**Source:** Leece-Neville Heavy Duty Systems Division – Arcade, NY

**Bulletin No:** TSB-1194

**Subject:** 8MR to A1743D and A1744H

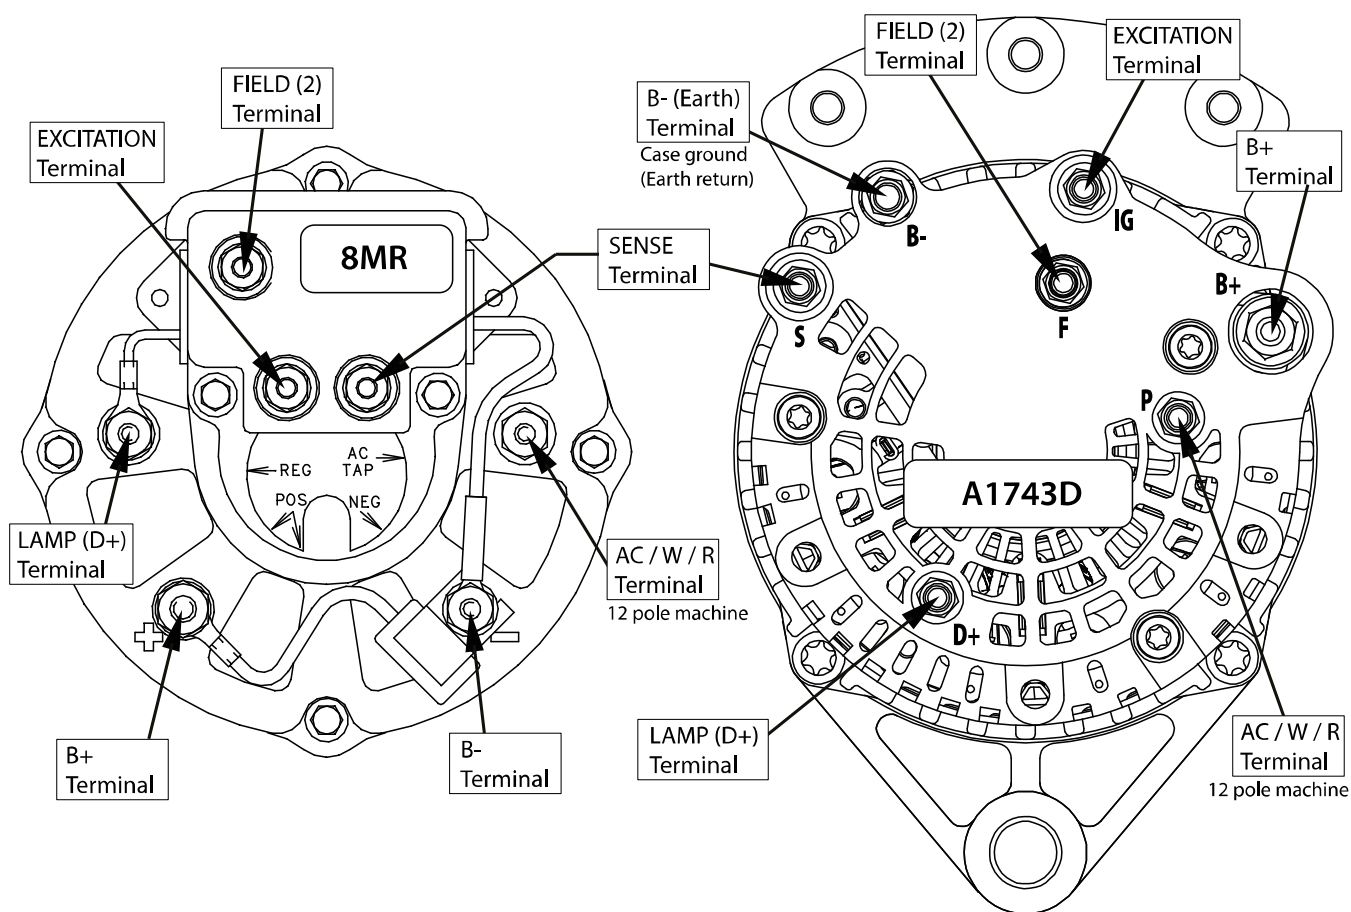
Alternator 8MR is discontinued and replaced by A1743D (105A) and A1744H (70A).

These alternators are direct mechanical (drop-in) replacements; however, they are **case ground (earth return)** machines.

**Note:** A1743D and A1744H have internal cooling fans. External fan used on 8MR is not needed.

This document will help identify terminal location variances.  
For detailed wiring diagram of the A1743D and A1744H see TWB-0054.
